## United States Department of the Interior

3482, SL-027304, U-66060, (UT-923)

Re: Minor Modification to Resource Recovery and Protection Plan (R2P2), Further Longwall Mining Plan Revision, Aberdeen Mine

Enclosure  
Approved Mine Map

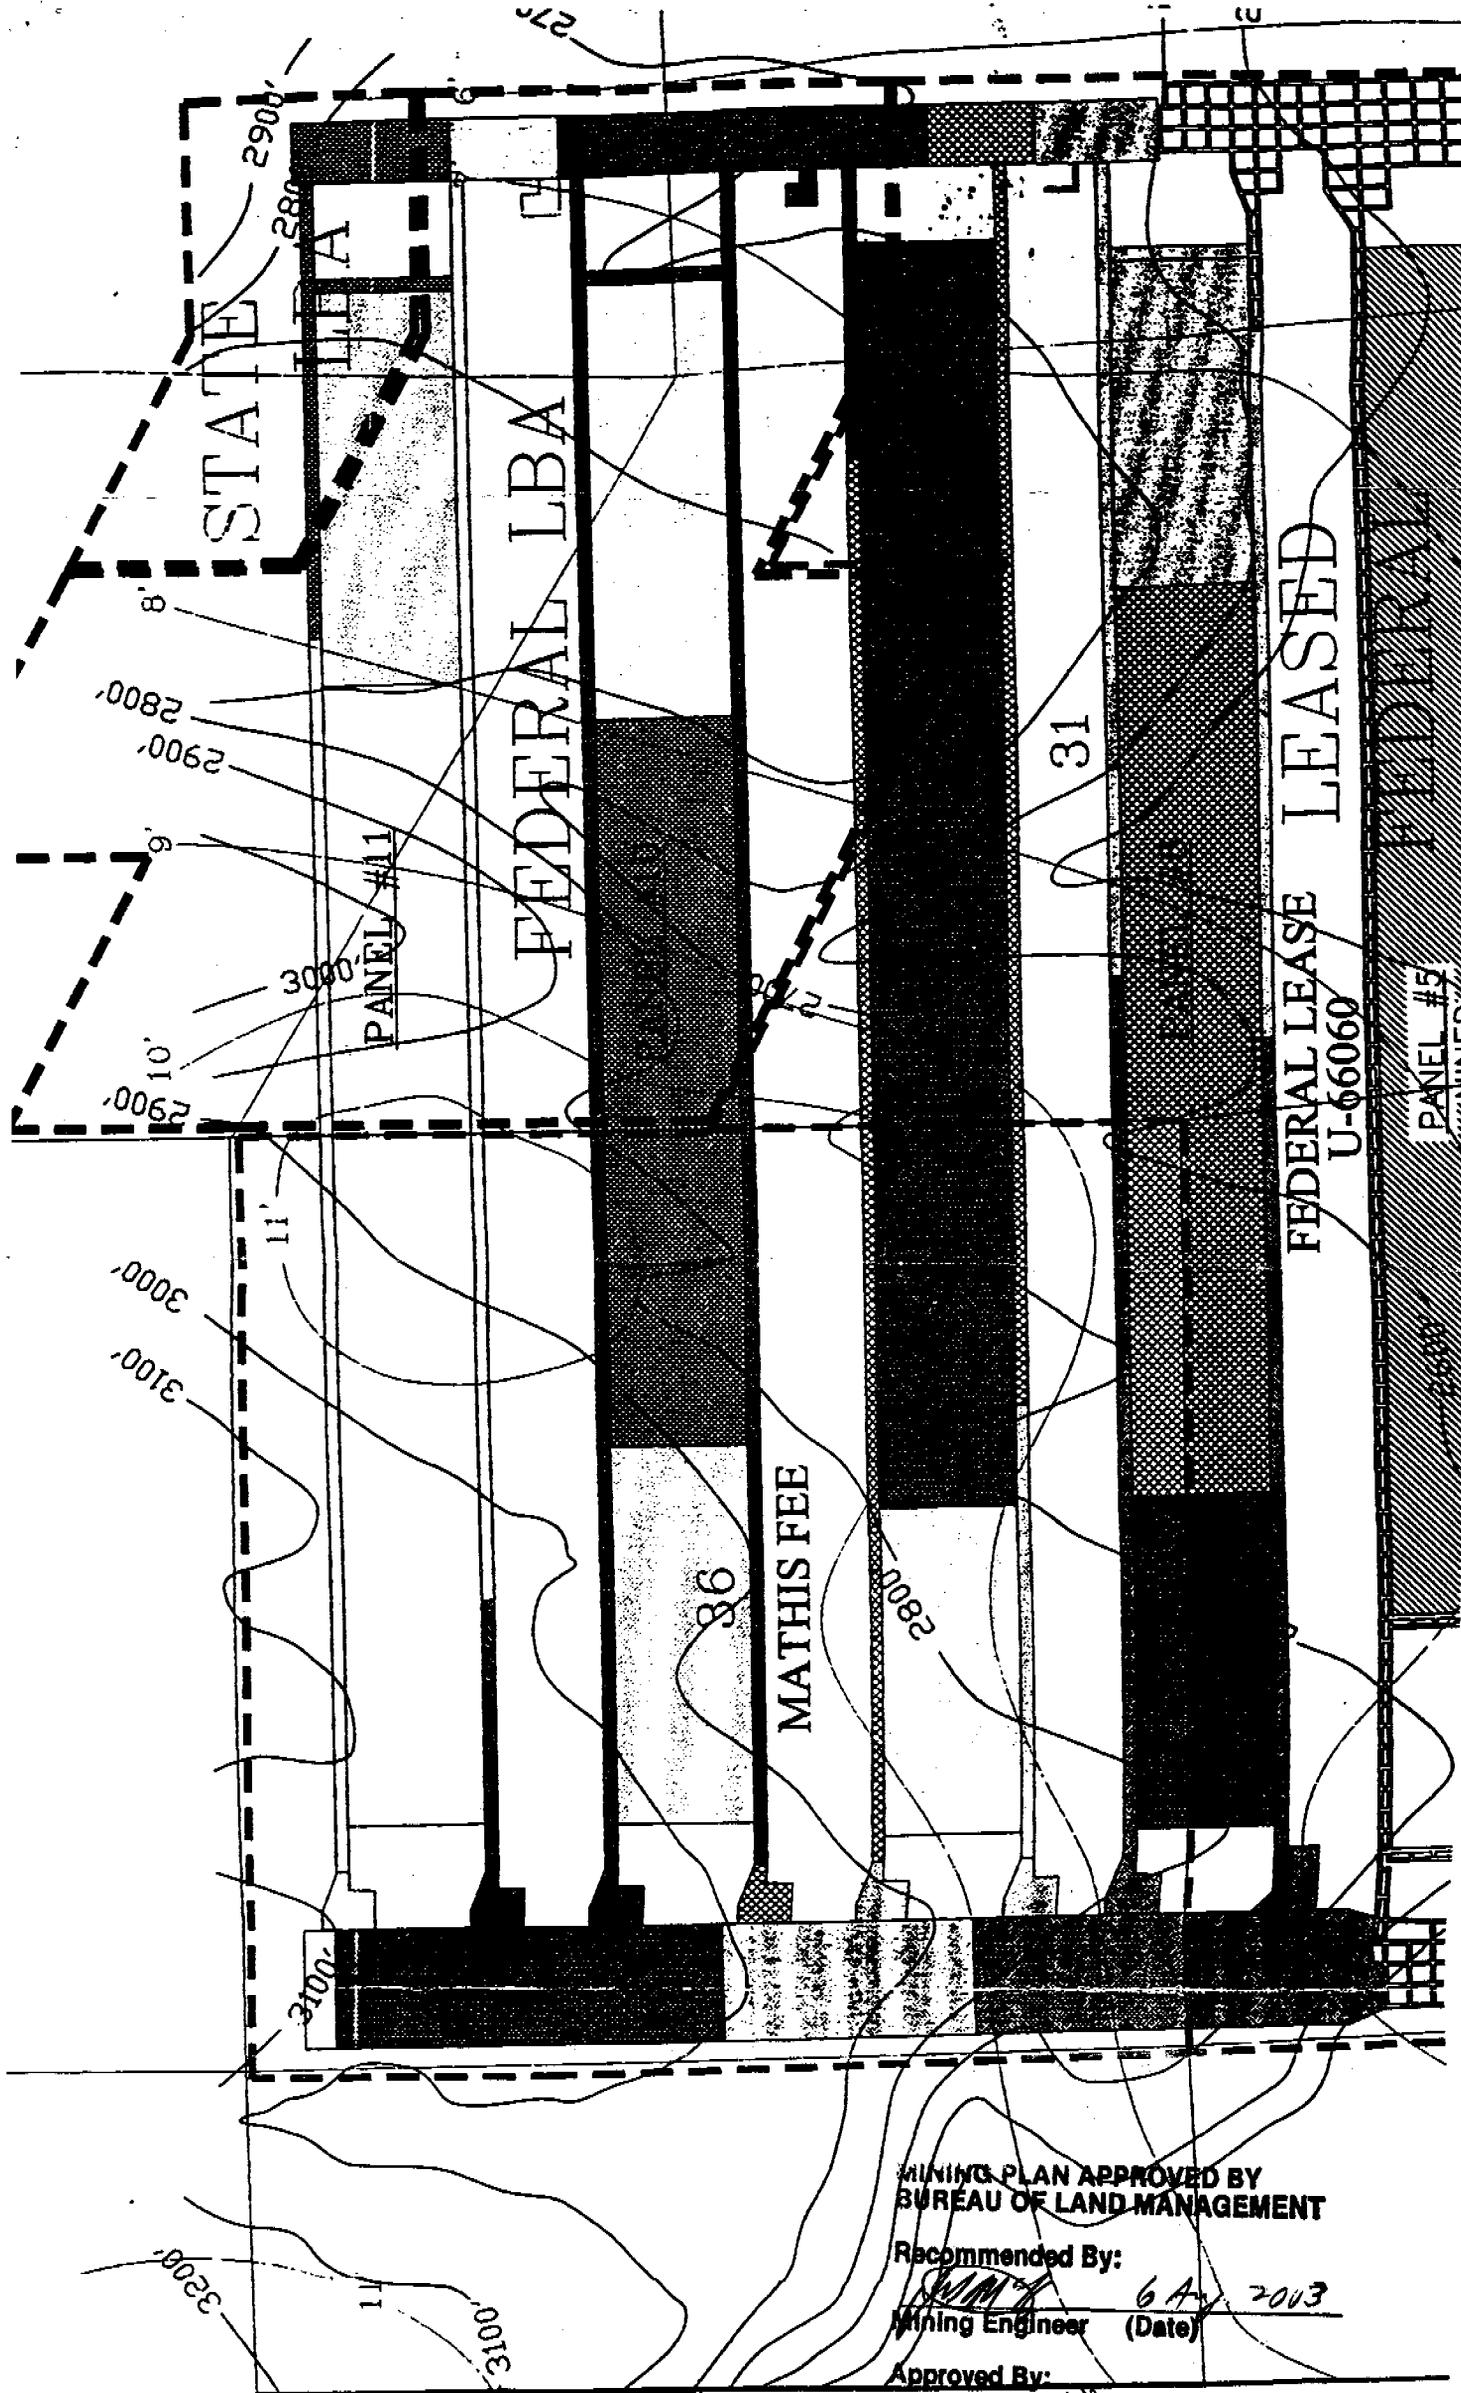
The proposed modification from Andalex meets the requirements of the Mineral Leasing Act of 1920, as amended, the regulations at 43 CFR 3480, the lease terms and conditions, and will achieve maximum economic recovery of the Federal coal. Andalex is authorized to develop and extract longwall panel # 6 and make West Mains a 5 entry main access way as shown on the enclosed mine map. The submitted R2P2 modification depicts further longwall mining north of panel # 6. The BLM agrees with the plan in principle, but will act on the plan if Andalex is successful in obtaining the proposed Summit Creek Lease Tract.

A copy of the approved mine map is enclosed with the approval area highlighted in yellow. If you have any questions, please contact Stephen Falk at the Price Field Office or Jeff McKenzie of my staff.
